9-2-21

Photo 1 of 10

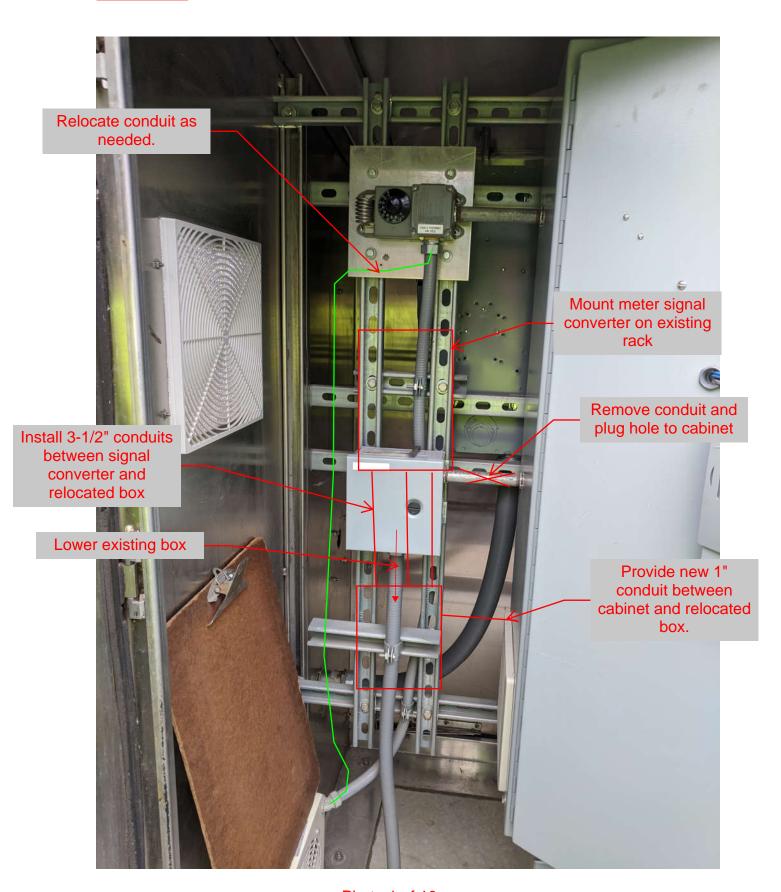
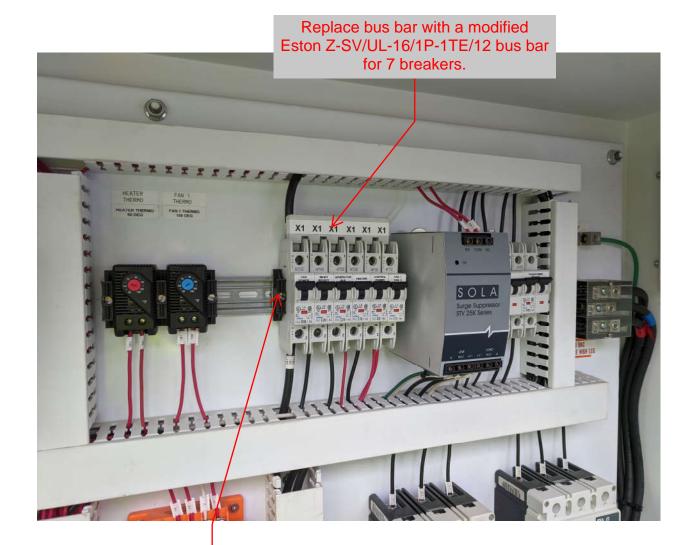
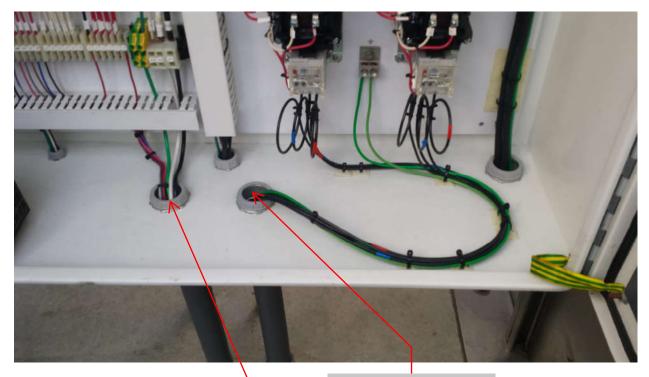
Install new FA2-C2/1-NA break for power to meter signal converter

Pump power conduit

Feed flow meter cables (2) from controller to flow meter through conduit

Photo 8 of 10

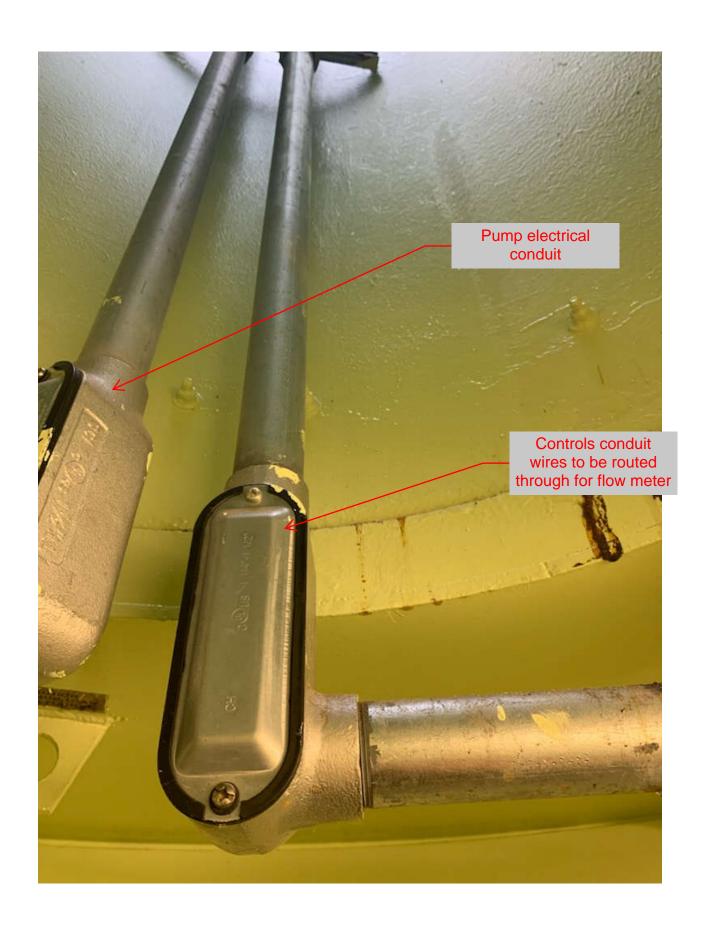
Relocate shelf 2' to the right of the force main riser and reinstall dehumidifier. Humidifier plug wire to be secured to the wall of the can.
